IDAP REPORT

Property:	2 Hydebrae Street STRATHFIELD
Proposal:	Demolition of an existing brick dwelling house and construction of a new two-storey detached dwelling house with in-ground swimming pool and removal of trees.
Applicant:	Y SQUARE STUDIO
Owner:	Yi Tong / Min Zhu
Date of lodgement:	8 April 2020
Notification period:	14 April 2020 to 30 April 2020
Submissions received:	One written submission received
Assessment officer:	PS
Estimated cost of works:	\$1,842,500
Zoning:	R2-Low Density Residential - SLEP 2012
Heritage:	Subject site is immediately adjacent to a Heritage Item and a Heritage Conservation Area
Flood affected:	No
RECOMMENDATION OF OFFICER:	Refusal

Figure 14. South west elevation of the dwelling house

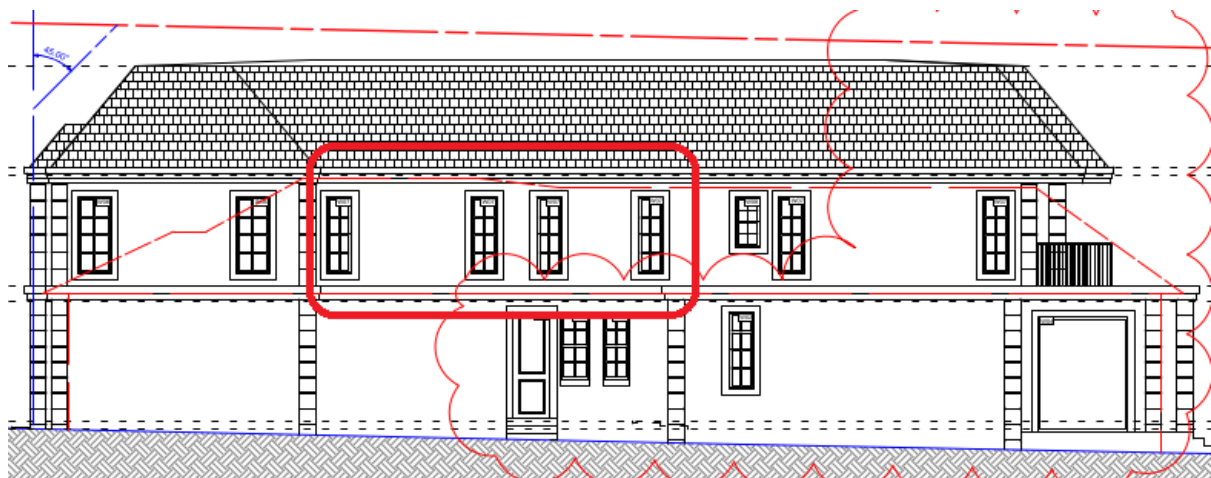
- *“Loss of privacy to the residents of 4 Hydebrae Street arising from windows on the boundary side with our property proposed for the second storey would be very material, unreasonable and unacceptable.”*

The south west elevation of the proposed dwelling house is the nearest to 4 Hydebrae Street. It is recognised that four windows on the elevation are next to the first floor living room and the stairway. See Figure 14 below. The areas next to the windows are considered of high activity use that can cause overlooking to the neighbouring property. Should the proposal be supported, the windows will be needed to be obscured or amended to highlight windows.

8. The application is considered not acceptable under the provisions of S4.15(1)(d) of the EP&A Act in that the proposal has failed to consider the windows to the high use activity area on the first floor that may overlook onto the immediate neighbour, which causes a visual privacy concern.
